CITY OF ALBUQUERQUE

Re: Universe Street Capacity Analysis ~~X~~
Engineer's Stamp Date 2/14/13 (C09/D001B)

TO:	Curtis Cherne, PE, City Hydrologist
FROM:	J. Graeme Means, PE
CC:	Martin Eckert, APS Real Estate Director, Annelle Darby, APS Staff Architect Jeff Mortensen, HMCG Principal Engineer
DATE:	02/26/2013
PROJECT:	APS Volcano Vista High School – City Hydrology File C7/D9
RE:	Summary Analysis of Connection to Proposed Storm Drain in Universe Blvd. NW
JOB NO:	HMCG 2012.182.9

Re: Universe Storm Drain – City Project # 761283

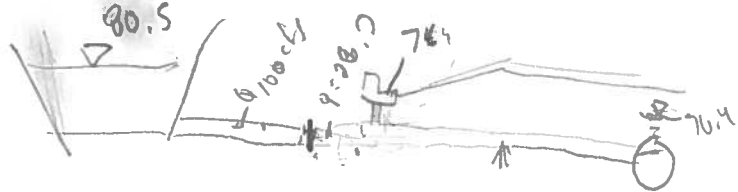
> 29 cfs ok

Q
29.57 cfs - Q_{min}
Q_{min} 29.5-33 = 26.2 cfs
